**Amendments to the Drawings:**

**REMARKS/ARGUMENTS**

This paper is submitted responsive to the Office Action mailed December 20, 2005. Reconsideration of this application in light of the accompanying remarks and amendments is courteously solicited.

Fig. 1

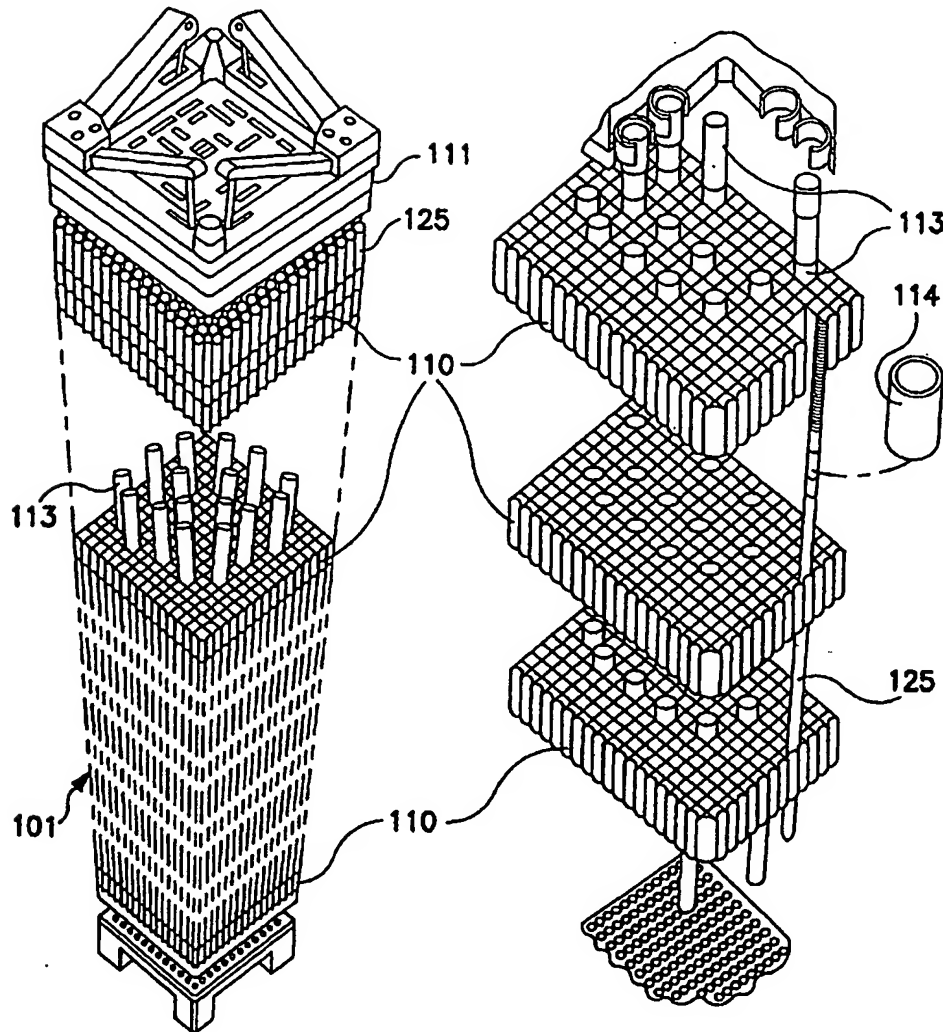
The attached sheets of drawings include changes to Figures 1, 2A, 2B, 3A and 3B, which have been designated "prior art" as requested by the Examiner.

1. The Examiner required amendment of Figures 1, 2A, 2B, 3A and 3B to designate --Prior Art--.
2. The Examiner declined to enter the previous proposed drawing corrections as drawn to new matter.
3. The Examiner held the change of "equiangular" to "conformal", "unit strip" to "cell wall", and "perimeter strips encircling intersecting inner strips" from page 12 as either unnecessary or new matter.
4. The Examiner rejected claims 1-8 as drawn to new matter based upon "perimeter strips encircling the intersecting inner strips".
5. The Examiner rejected claims 7 and 8 as drawn to new matter, apparently based upon the claimed grid springs.
6. The Examiner rejected claims 3-5 as indefinite.
7. The Examiner rejected claims 1-5 over prior art.

(Prior Art)

Added

The requested change to the drawings has been made and this objection is therefore believed to be resolved.

Fig. 2A

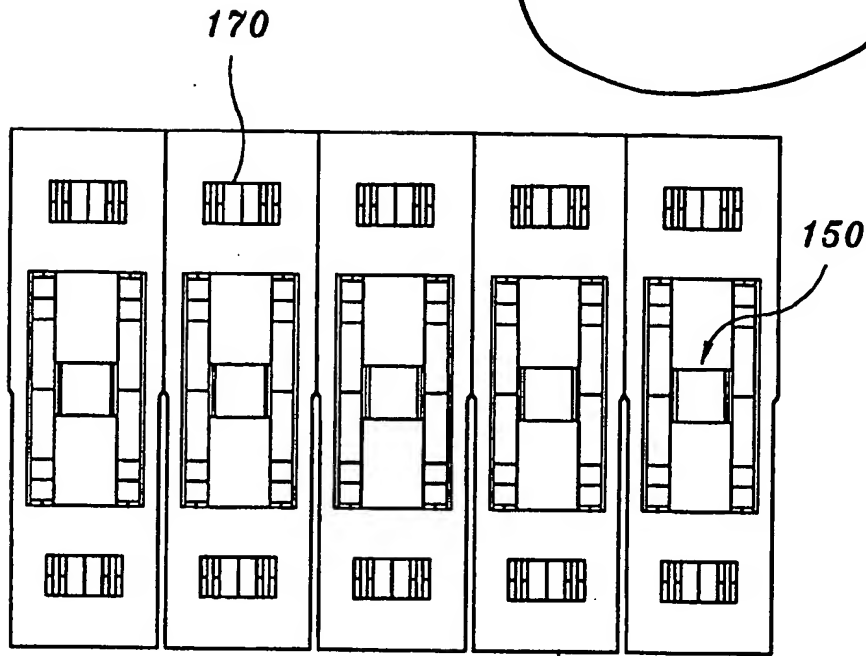
(Prior Art)

Added

Fig. 2B

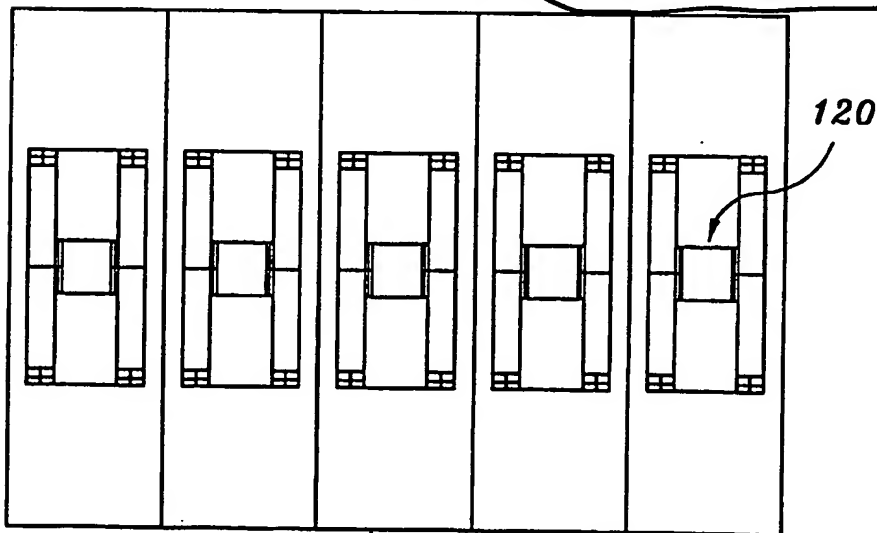
(Prior Art)

Added

Fig. 3A

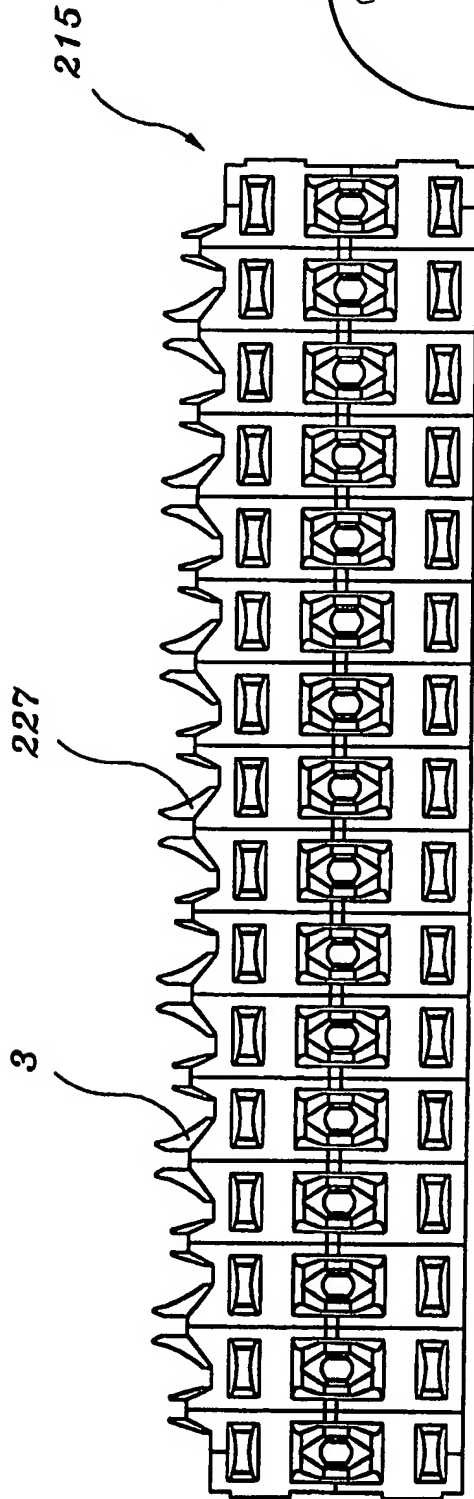
(Prior Art)

Added
